ENGINE - PROVIDE STAGE 1.5 AND 2.0 STATOR ASSEMBLIES WITH OUTER SHROUDS HAVING REDUCED THICKNESS - CATEGORY CODE 7 - MOD.ENG-72-0008

V2500-ENG-72-0008

LP compressor stage 1.5 and 2.0 stator assemblies - Before and after alteration
Fig.1, Sheet 1 of 3

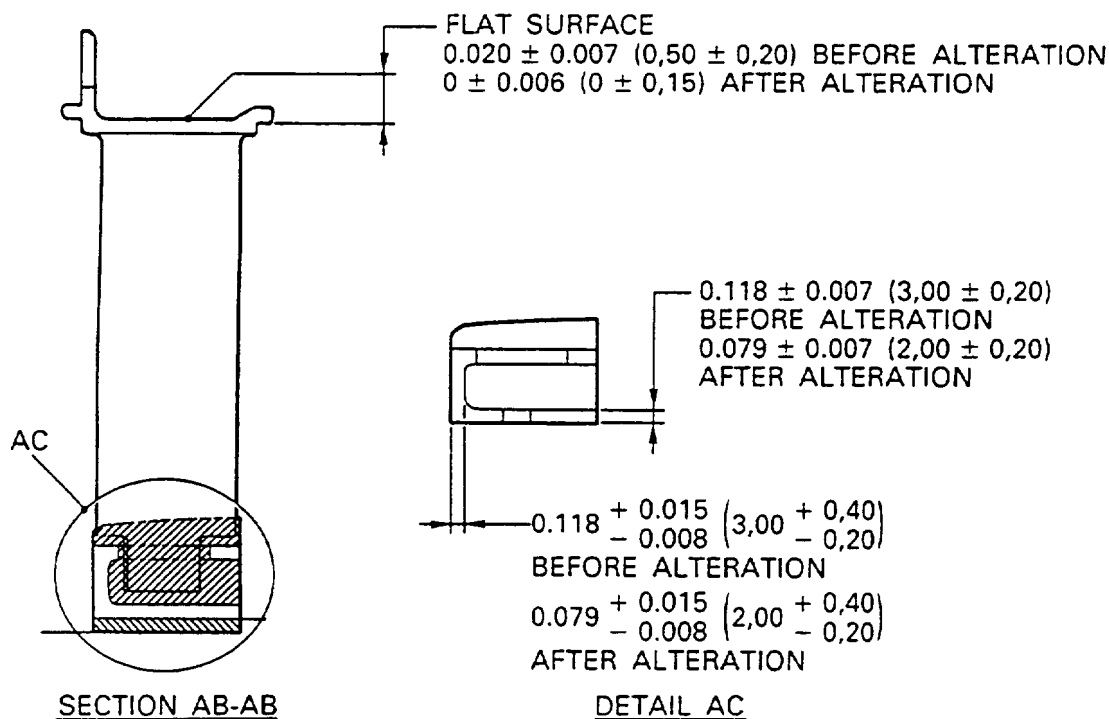
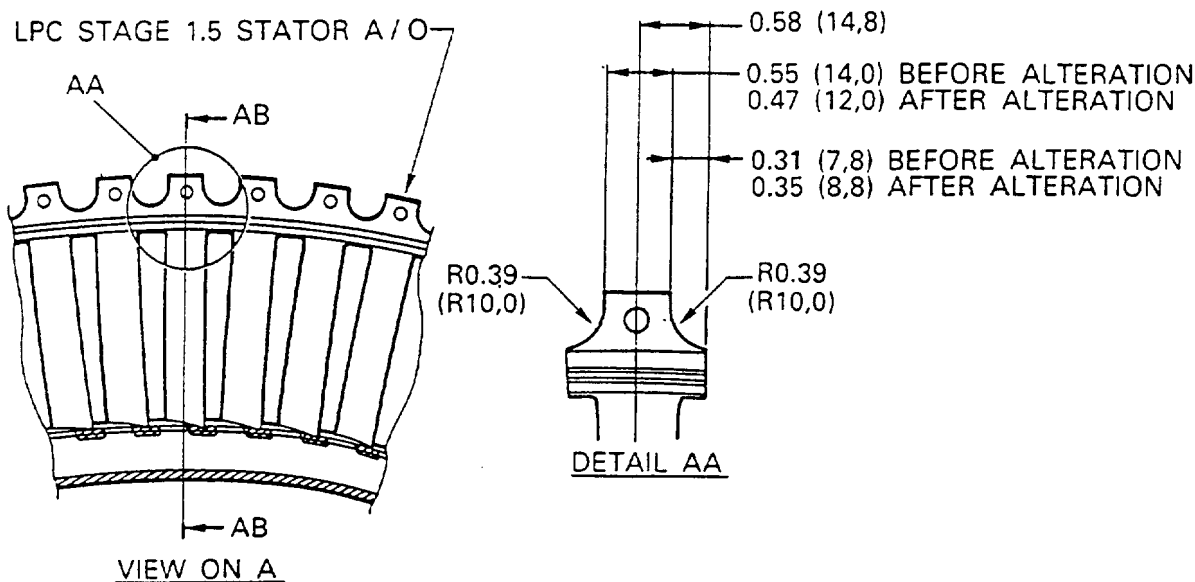
- (1) New LP Compressor Stage 1.5 and 2.0 Stator Assemblies which have the following changes for reducing weight have been introduced.
 - (a) The thickness of each LPC Stage 1.5 and 2.0 vane outer shroud has been reduced. (See Figure 1.)
 - (b) The scallops of each LPC Stage 1.5 and 2.0 vane have been enlarged. (See Figure 1.)
 - (c) The thickness of the LPC Stage 1.5 Vane inner ring has been reduced. (See Figure 1, Sheet 2.)
- (2) New LPC Stage 1.5 Stator A/O and new LPC Stage 2.0 Stator A/O will be available for future replacement purposes.

LP compressor stage 1.5 and 2.0 stator assemblies - Before and after alteration
Fig.1, Sheet 2 of 3

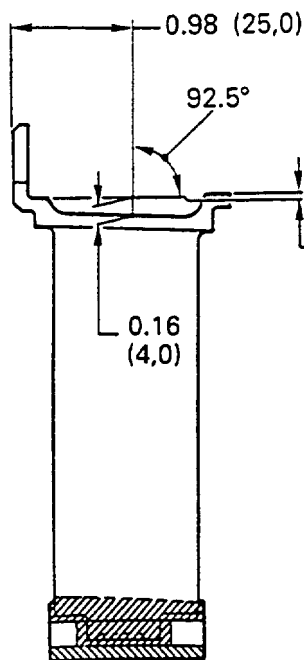
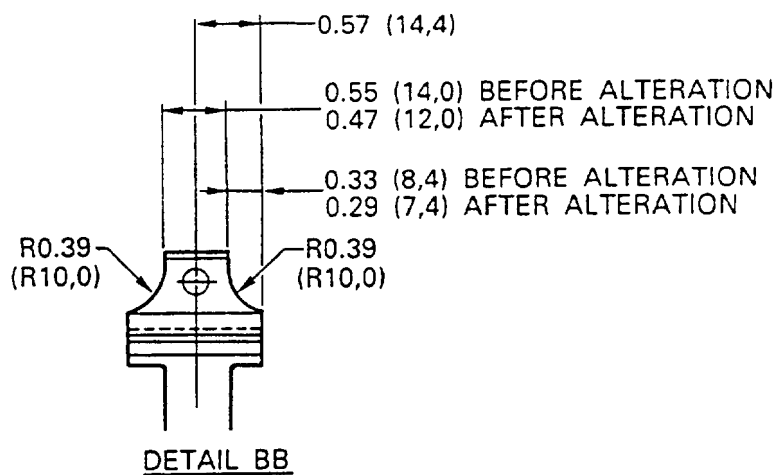
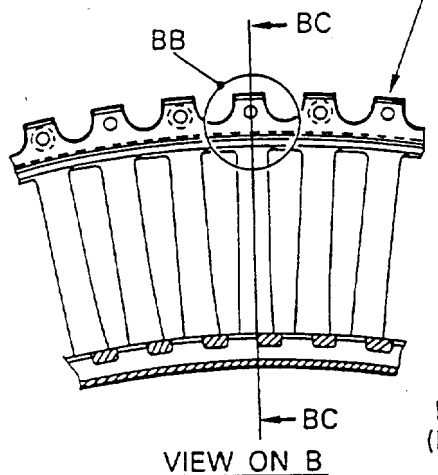
FLAT SURFACE
 0.004 ± 0.004 (0,10 \pm 0,10) BEFORE ALTERATION
 0.020 ± 0.004 (0,50 \pm 0,10) AFTER ALTERATION
